**DESIGN-BUILD REPLACEMENT OUTDOOR DIGITAL SIGNAGE
LYNX CENTRAL STATION
RFP 18-R03
ADDENDUM NUMBER FOUR (4)
DECEMBER 22, 2017**

Request for Proposal (RFP)

ORIGINAL DATE DRAWN: JUNE 3, 2004
SALES PERSON: TOM KITCHELL
DRAWING NUMBER: G-35

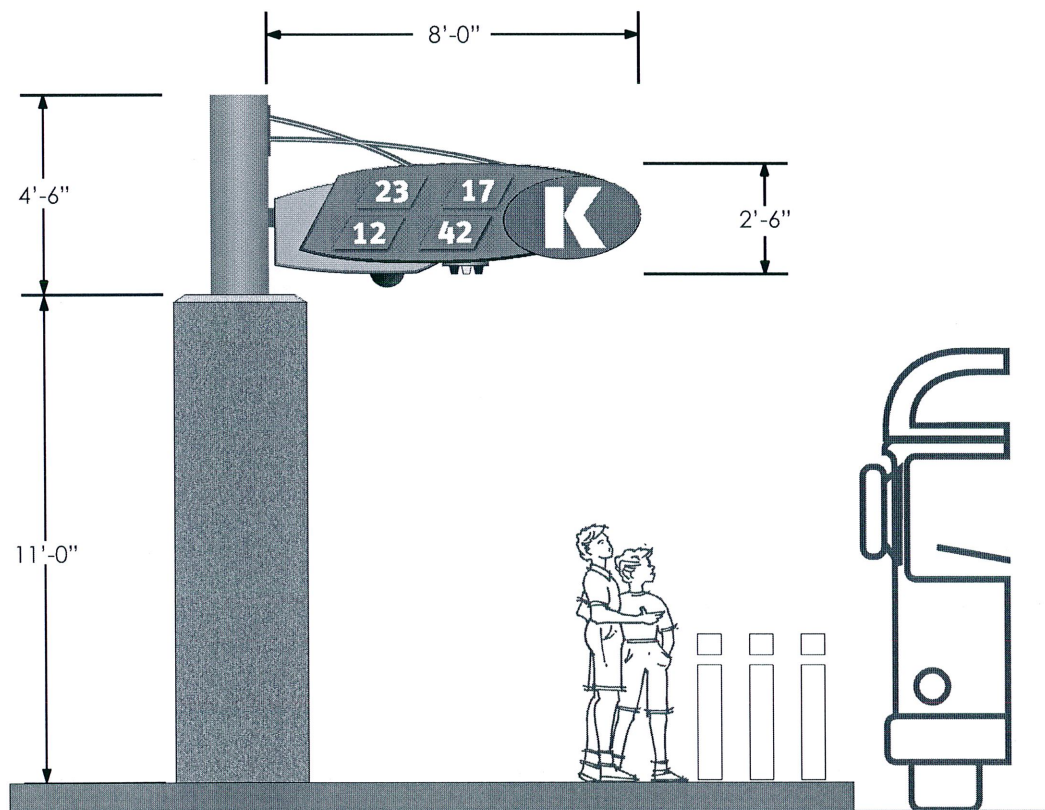
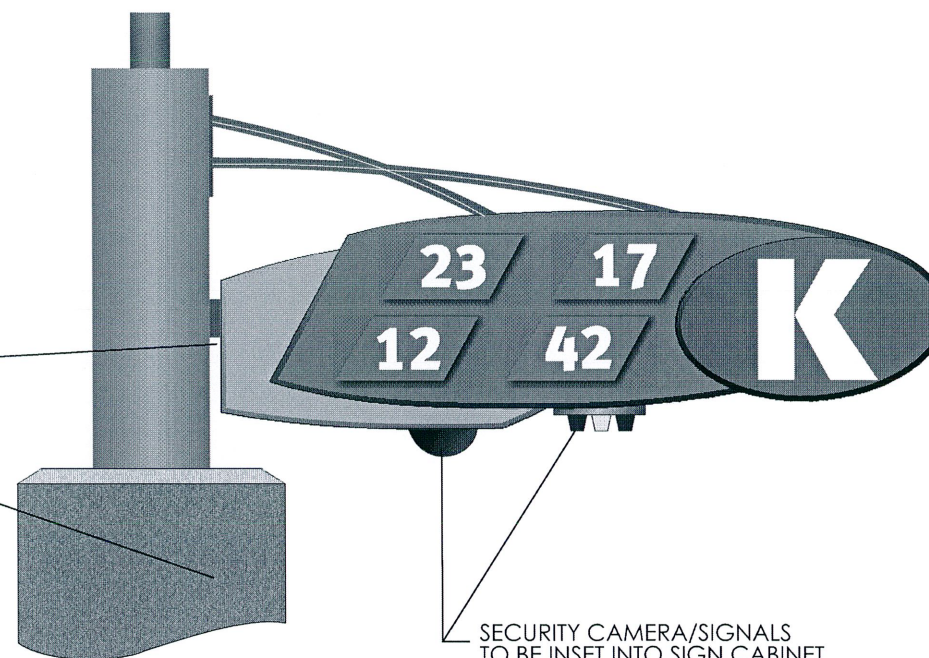
B. There isn't a camera mounted on the sign in the picture. How many signs have cameras?

Response: Bay D and Bay M have a security camera installed at the bottom of the existing sign structure. These are the only two bays with cameras attached to the sign structure.
